**Re: ZB-21-08 – Main West Orange LLC
Block: 116; Lots: 51, 53, 53.01, 55; Zone: B-1 and R-T
253-255, 257, 259 Main Street
Site Plan Review Advisory Board Report Response**

RE: **ZB-21-08 – Main West Orange LLC**
Block: 116; Lots: 51, 53, 53.01, 55; Zone: B-1 and R-T
253-255, 257, 259 Main Street
Site Plan Review Advisory Board Report

LLEWELLYN HOTEL RENOVATION
BLOCK 116, LOTS 51, 53, 53.01 & 55
259 MAIN STREET
WEST ORANGE, NJ 07052

SITE PLAN/GRADING PLAN
BLOCK 116 - LOTS 51, 53, 53.01 & 55
TAX MAP SHEET No. 26
259 MAIN STREET
FOR
MAIN WEST ORANGE, LLC
TOWNSHIP OF WEST ORANGE, ESSEX CO., N.J.

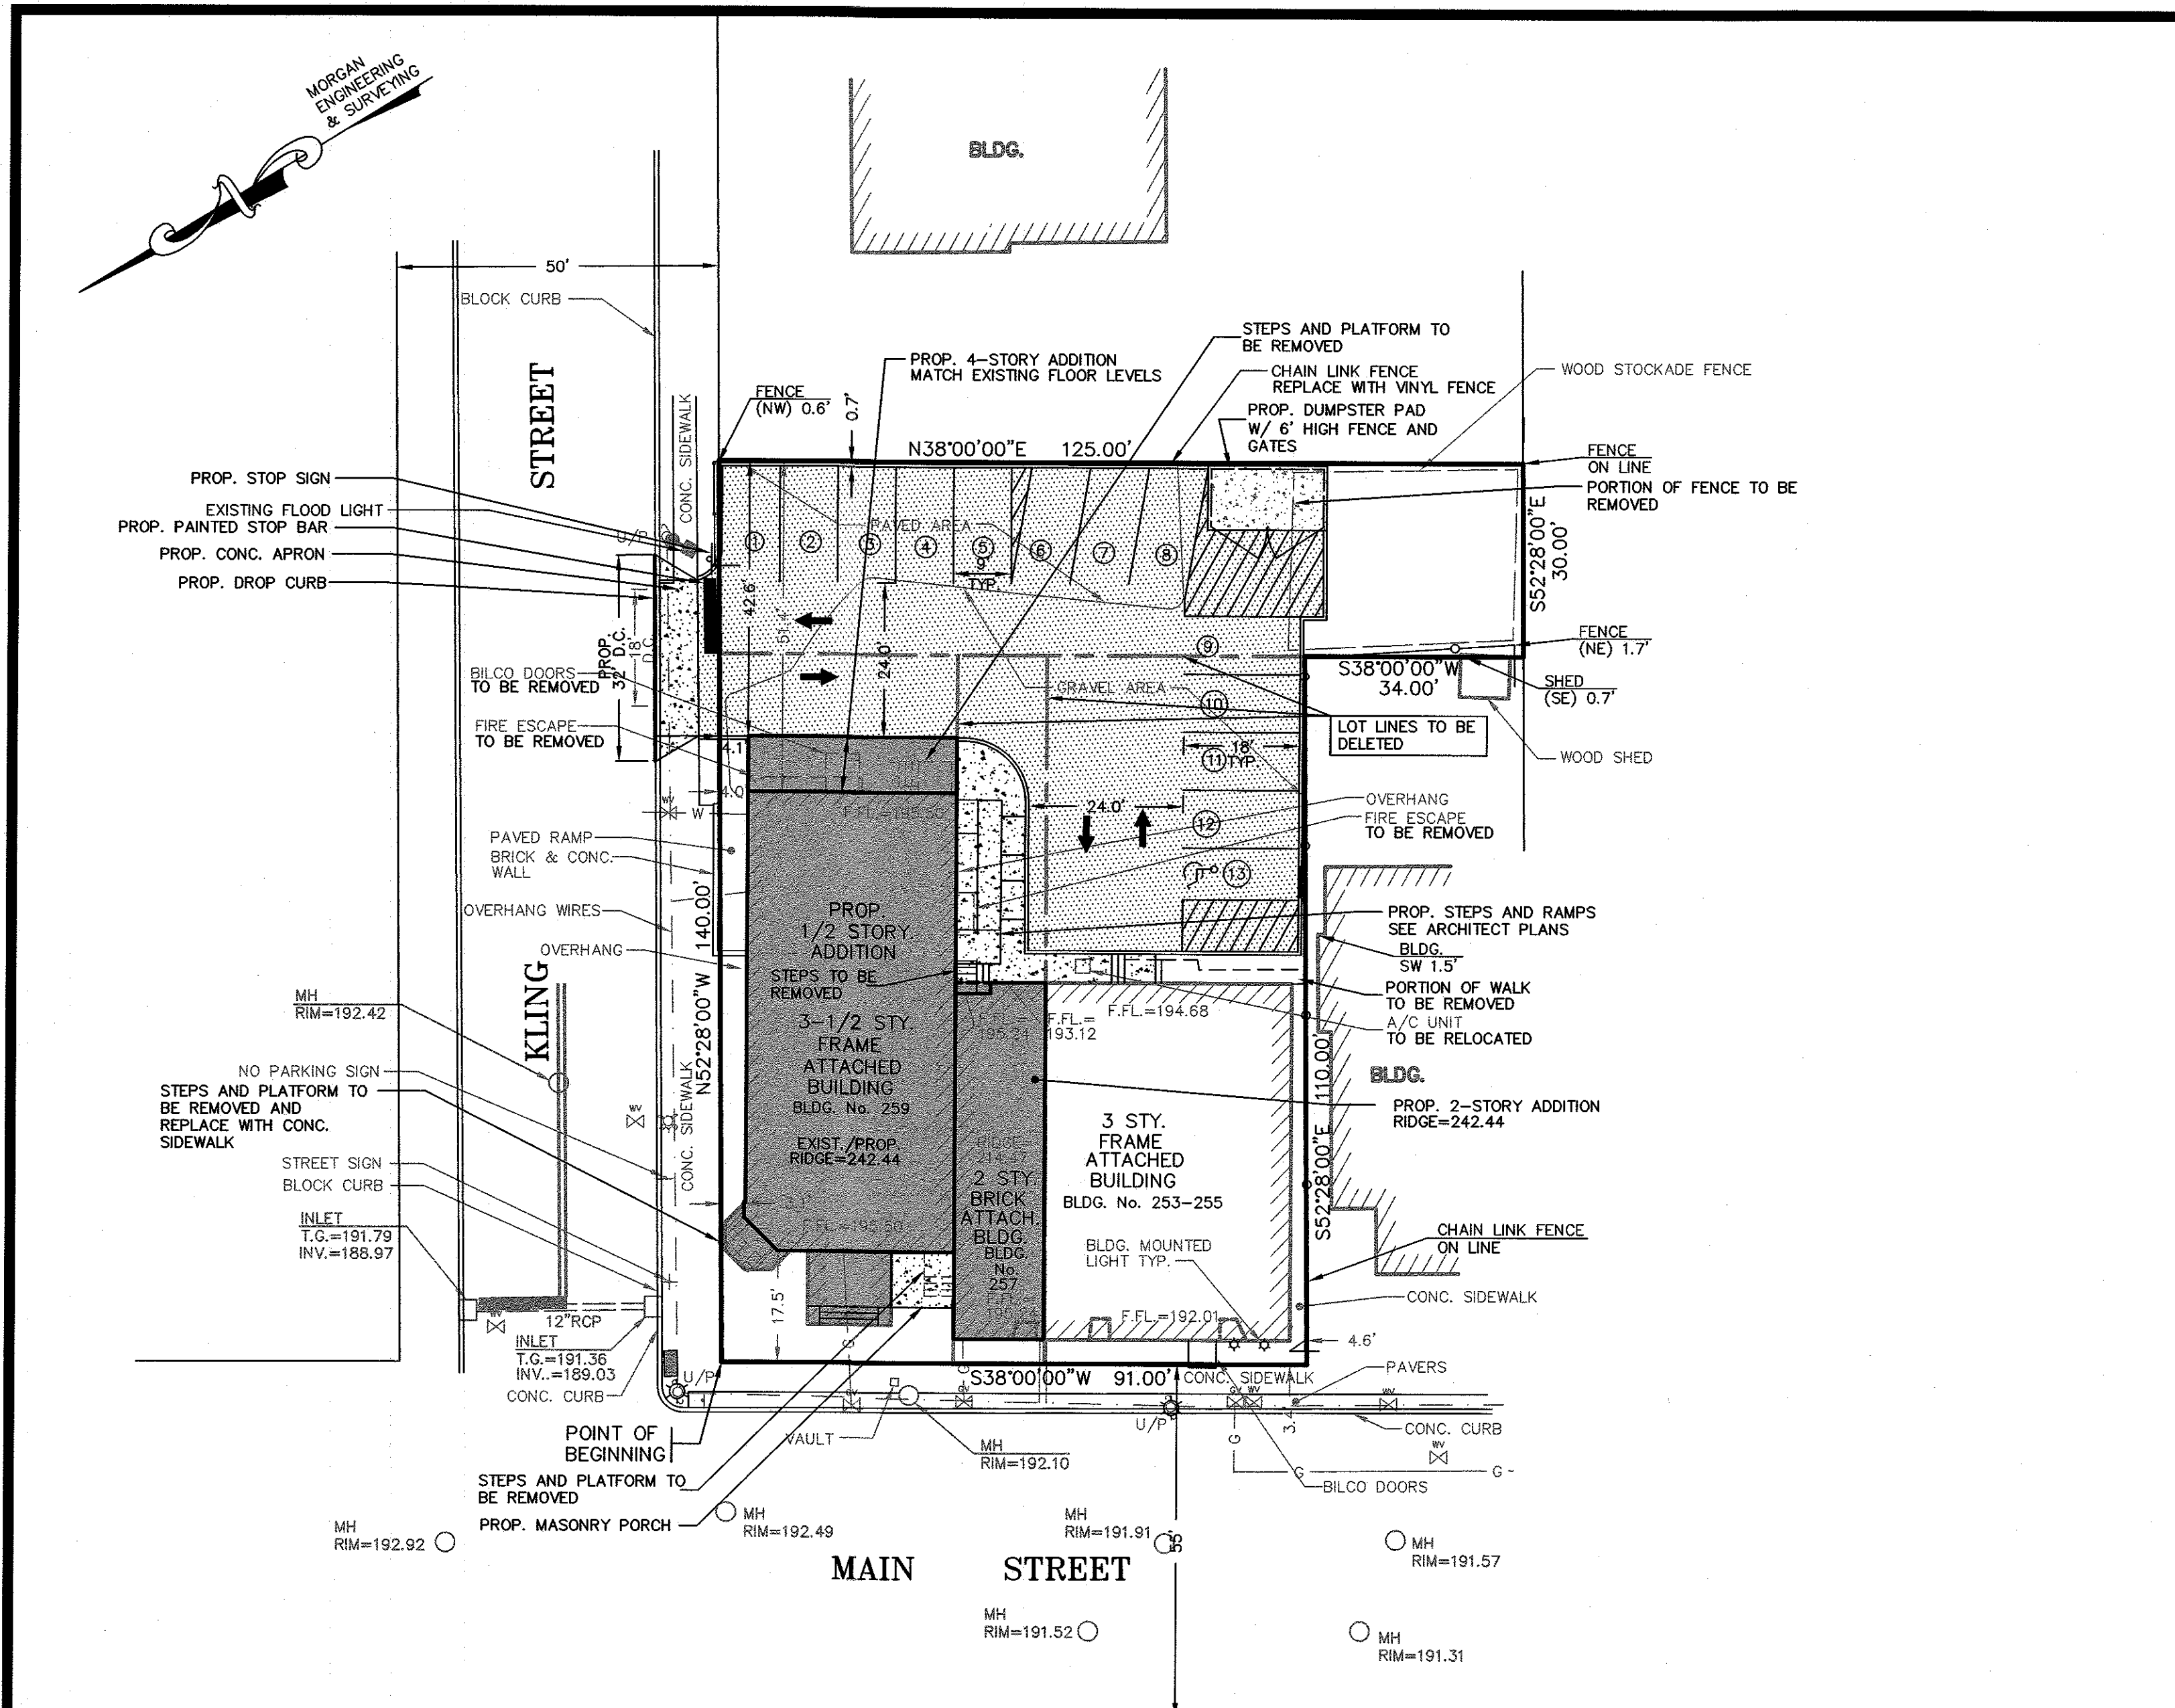
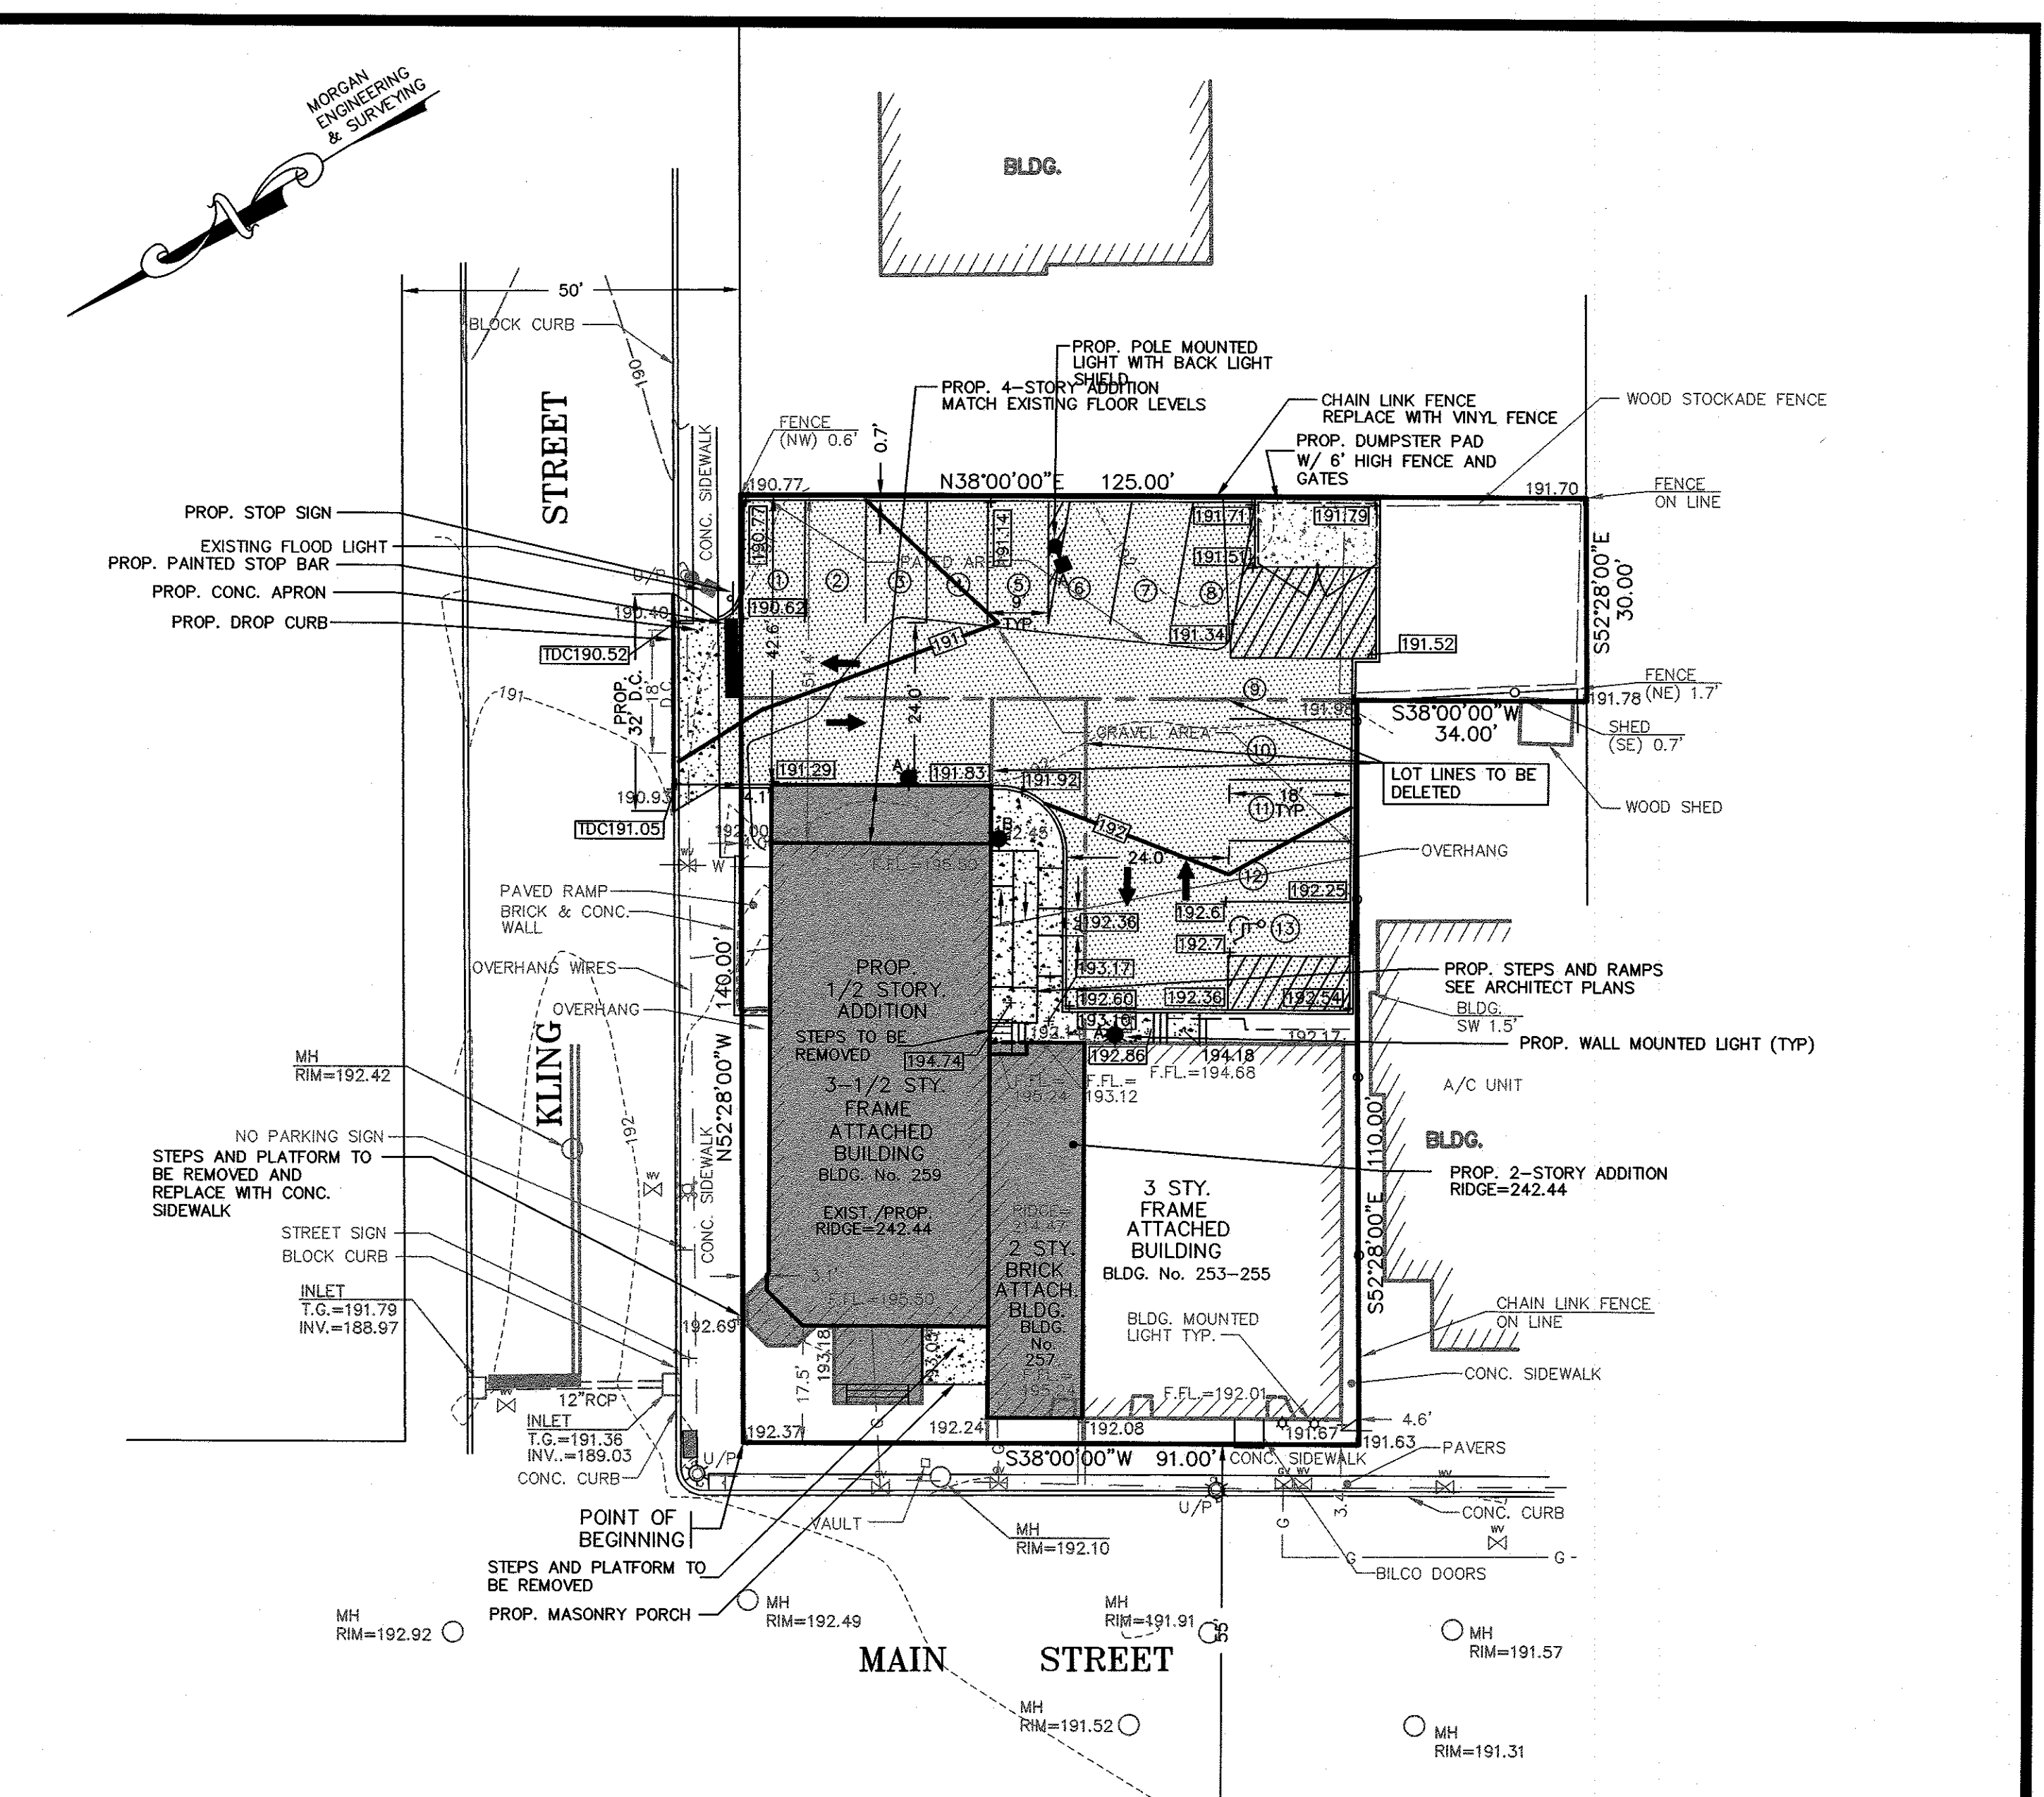
- Existing conditions: The subject property consists of four tax lots with three buildings located on them. Two of the buildings are being modified and expanded while one will remain unchanged. However, the site plan and architectural plans need to be updated to include all information for all existing and proposed buildings in terms of parking requirements and other zoning compliance. The four lots will need to be consolidated if the application is approved.

1. Existing Conditions – Attached are revised architectural plans indicating remaining apartment dated August 11, 2021 by Axis Architectural Group in response to this item. Also included are engineering plans by Schwanewede/Hals Engineering last revised on August 30, 2021 indicating lot lines to be deleted due to lot consolidation.
